UNITED STATES PATENT AND TRADEMARK OFFICE

APPLICATION NO.	FILING DATE	FIRST NAMED INVENTOR	ATTORNEY DOCKET NO.	CONFIRMATION NO.
09/681,403	03/29/2001	Tore Fosse	VCC0082-US	3278

Office Action Summary

FIG. 1

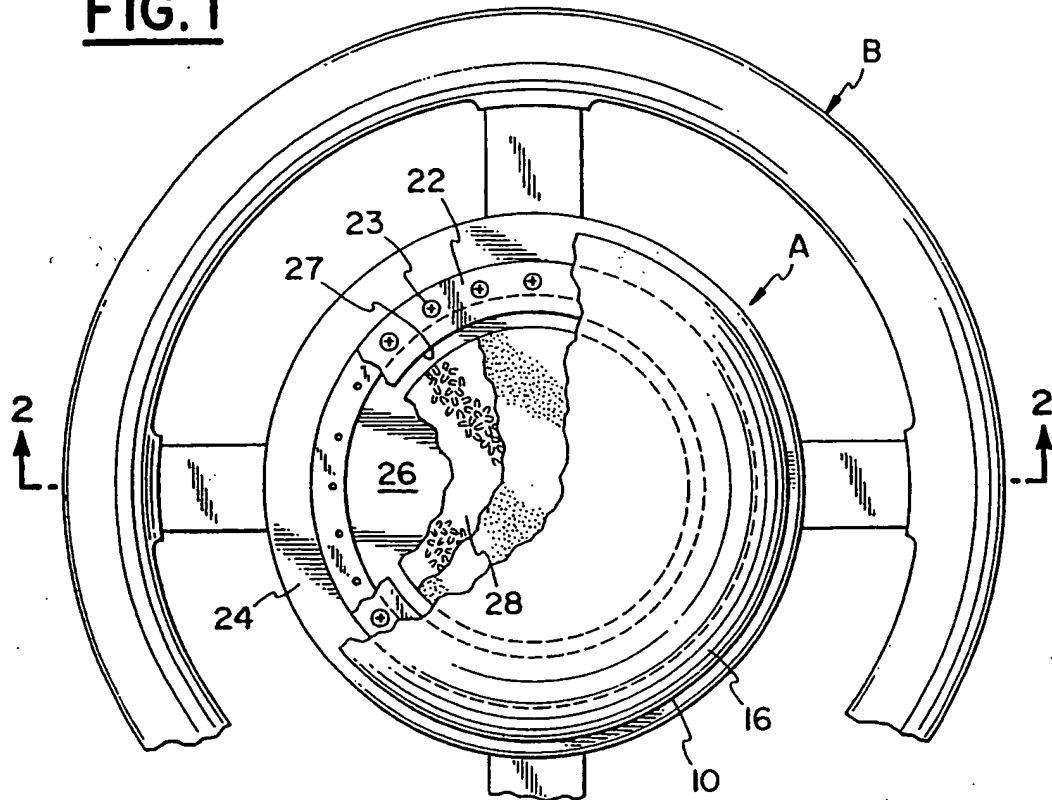
Claims 21, 22, and 27 – 42 are rejected under 35 U.S.C. 103(a) as being unpatentable over Young (US 5,480,184). Young discloses a hub (see Fig. 2) for fixing to a steering column (S in Fig. 2), a substantially conical bowl-shaped element (see Fig. 2) connected to the hub with at least one spoke (see Figs. 1, 2), the spoke further connecting the bowl-shaped element to a steering wheel rim (B in Fig. 1, 2), wherein the hub, bowl-shaped element, and at least one spoke are integrally formed as a single material item (see Fig. 2), the bowl-shaped element further comprising an upper shell part (24 in Fig. 2) and lower shell part (see area near 19 in Fig. 2), the upper shell part having larger outer dimensions than the lower shell part and the upper and lower shell parts are connected by a ledge extending substantially in the radial direction relative to the

longitudinal axis of the steering column (see Fig. 2), the bowl-shaped element also comprising a casing for enclosing an airbag and means for inflating the airbag substantially disposed in the lower portion of the steering wheel (18 in Fig. 2), where a wall section of the bowl-shaped element at least partly forms part of the means for inflating the airbag (see area, attachment at 19 in Fig. 2).

Regarding Applicant's argument that Young does not teach or suggest a ledge that extends substantially in the radial direction relative to the longitudinal axis of the steering column, the examiner disagrees. Young shows a ledge, which extends substantially in a radial direction relative to the longitudinal axis, as shown in Figure 2 of the attachment.
